RESOLUTION AWARDING BID FOR TWO (2) FOURTEEN FOOT (14') DUMP BODIES WITH HYDRAULIC SYSTEMS FOR THE PUBLIC WORKS DEPARTMENT

Addendum #2

Two (2), Fourteen Foot (14') Dump Bodies with Hydraulic Systems For the Public Works Department

Addendum #1

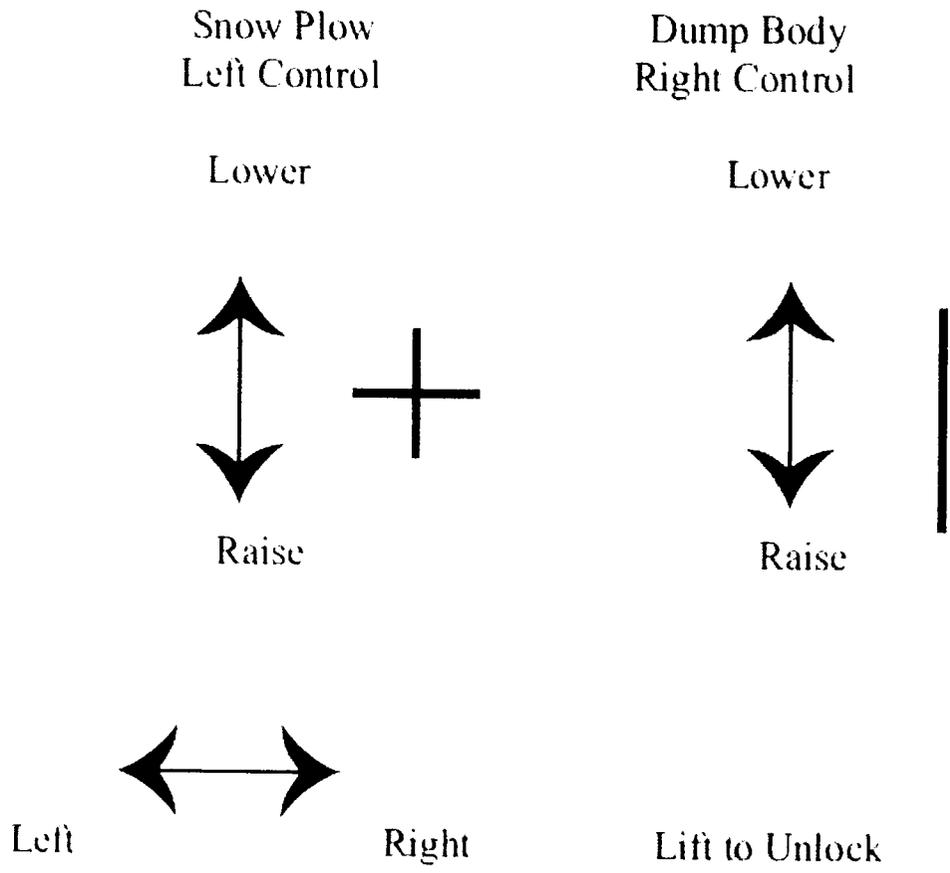
Question #7: J. Lights/Equipment. 10: "Rear lower tail light panel shall include Two (2) Truck Lite 44322R LED stop/turn tail Lamps, Two (2) Truck Lite 44344C LED reverse lamps, One (1) Truck Lite 33740R 3 lamp clearance light set and four (4) Truck Lite 94707 plugs."

Where are these located? Are these needed as well as the Whelen 700 series kit?

Response: See attachment C rear lower tail light panel. You will also need the Whelen Dot3702A lights.
